Sandia Review of High Bridge Associates Report:

Comparison of Plutonium Disposition Alternatives: WIPP Diluted Plutonium Storage and MOX Fuel Irradiation

P. Shoemaker, E. Hardin, H. Park, P. Brady and R. Rechart
Sandia National Laboratories
August 1, 2016

subject: Commentary on Report by High Bridge Associates, Inc. dated March 2, 2016

Figure 1. A vertical cross section and a horizontal cross section of a 7x3 stack of CCOs in HAC configuration. Blue represents CCCs containing water, polyethylene, beryllium, and Pu. Red represents air. Other materials such as steel and plywood were ignored as reported for the Studsvik models.

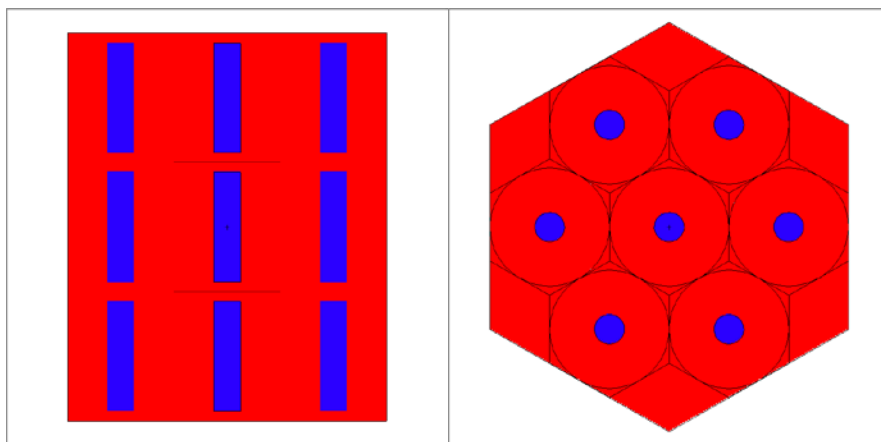
Figure 1 is a replicated model of a 7x3 stack of CCOs in HAC configuration (as stacked in the repository). MCNP used white boundary condition in the x- and y-directions, and black boundary condition in the z-direction, similar to the HBA models. HBA does not report whether their model includes air or vacuum between drums, so for the MCNP models air was assumed between the CCOs and to the boundaries. The replicated model has a difference of about 8% in k-eff:

The geometry of this model is not an exact replica of Studsvik's model as the report lacked information about how stacked drums were modeled, and what materials were assumed in the vicinity. Although the results obtained using MCNP are in general agreement with results from Studsvik using KENOVI, the differences may be attributable to these factors.

Figure 2. The CCOs are radially compressed to a third of original volume, and the pitch between CCCs is decreased to 21 cm, but the CCCs are not compressed. The white area inside the boundary represents vacuum (no interaction with neutrons) and an all-black boundary condition is applied.

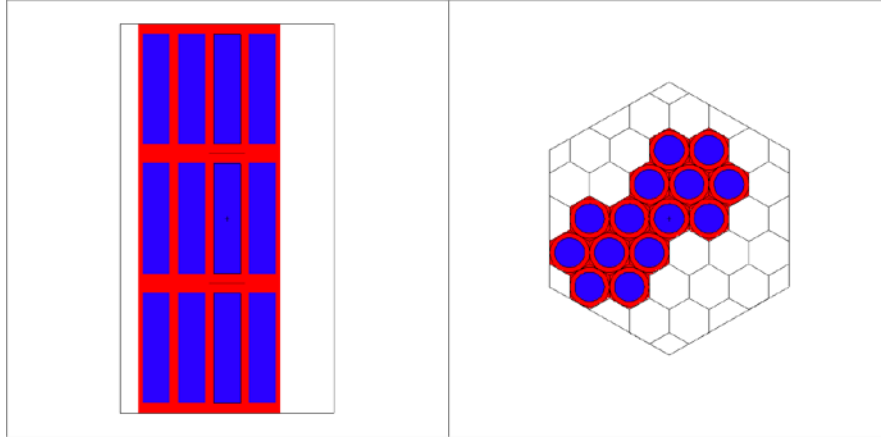
In the HBA report, the only compaction factor mentioned is decreasing pitch for CCOs from 61 cm to 20 cm to simulate compaction. The difference in k-eff is 4% for this case:

As an additional example, Salado brine was introduced into the model shown in Figure 2. The boundary condition is black all around, the same as the previous simulation. Brine was introduced between CCOs and between the CCC and drum for each CCO, but it was not placed on the top or bottom of the stacks.

Two Compacted 7x3 Stacks with Black Boundary (Figure 2)	k-eff (MCNP 2-D)	Error (\pm)
Only air surrounding the HAC stacks (replicating Studsvik model)	0.95259	0.00027
Brine between CCOs and inside CCOs	0.79065	0.00029

Figure 3. Top figures are the replicates for Case 1 from the HBA report (p. F-14), and the bottom figures are the replicates for Case 2 (left) and Case 3 (right). Red represents MgO, yellow is air, and blue represents CCCs.

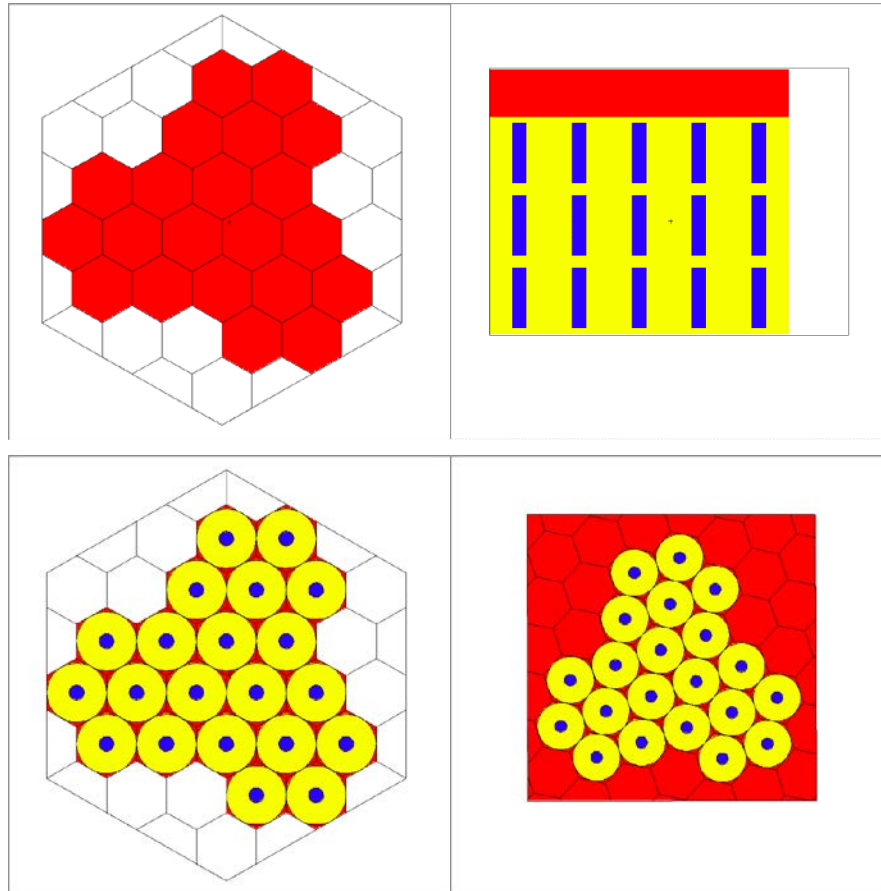
Case 3 has the supersacks on top of each 7x3 stack, in between CCOs, and all around the outside of the three 7x3 stacks (Figure 3). The resulting k-eff is:

MgO supersacks are designed to break open so that the MgO can migrate in between the drums; therefore, it is unrealistic to assume case 2 or 3 because MgO has to be either on top or in between the drum stacks. Case 3 includes a volume of MgO much greater than could be available in three 50 cm-thick supersacks.

Figure 5. Blue represents the homogeneous mixture with Pu, yellow represents air and red is Salado brine positioned in between drums, but not on top or bottom.

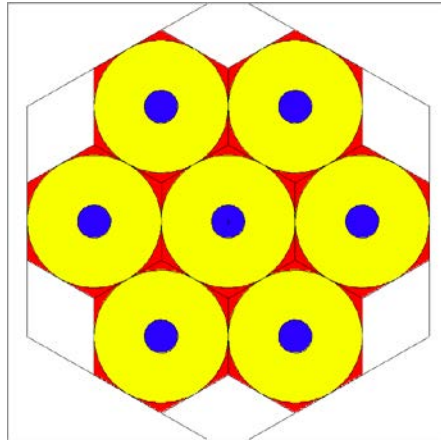
The model in Figure 5 has the same boundary conditions as the model in Figure 1. The only difference between the two is the thin layers of the brine between the CCOs. The difference in k-eff between the two cases tabulated below is about 0.12, which shows the significant negative effect of chloride (and boron) containing brine on k-eff.

7x3 Stack in HAC Configuration with Surrounding Medium (Figures 1 and 5)	k-eff (MCNP 2-D)	Error (\pm)
Air	0.79113	0.00026
Brine	0.67443	0.00023
